70320A-01A

S E R V I C E N O T E

HP 70320A Synthesized Signal Generator

RPP Module Modification Reduces Noise Floor of RF Output

Fig 1

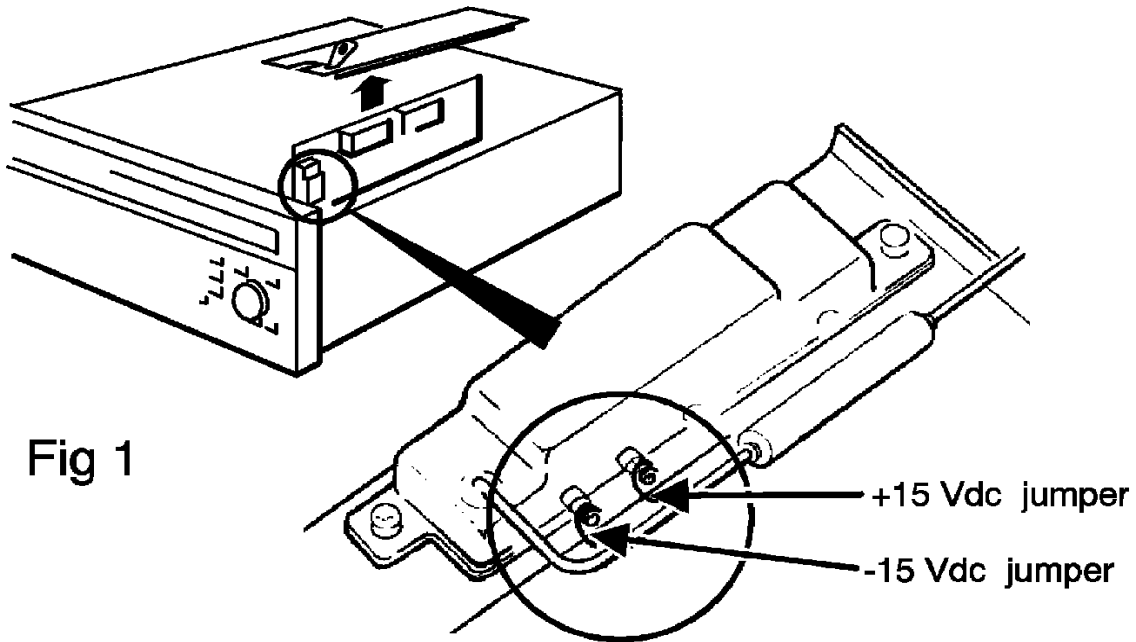
The RPP (Reverse Power Protection) module protects the RF output circuitry from damage. Instruments with serial numbers noted above have +15 Vdc and -15 Vdc bias voltage connected to the RPP module. It has been noted that the noise floor of the instrument is higher when the RPP module is connected to these bias voltages. Removing the bias voltages from the RPP module reduces the noise floor and does not affect the instrument's ability to protect the RF output circuitry. The typical reduction of the noise floor (for output levels less than -120 dBm) is 3 dB.

Clip out or de-solder two jumper wires which connect +15 Vdc and -15 Vdc to the RPP Module. Refer to Figure 1 for module/component location. Re-calibration is not required.
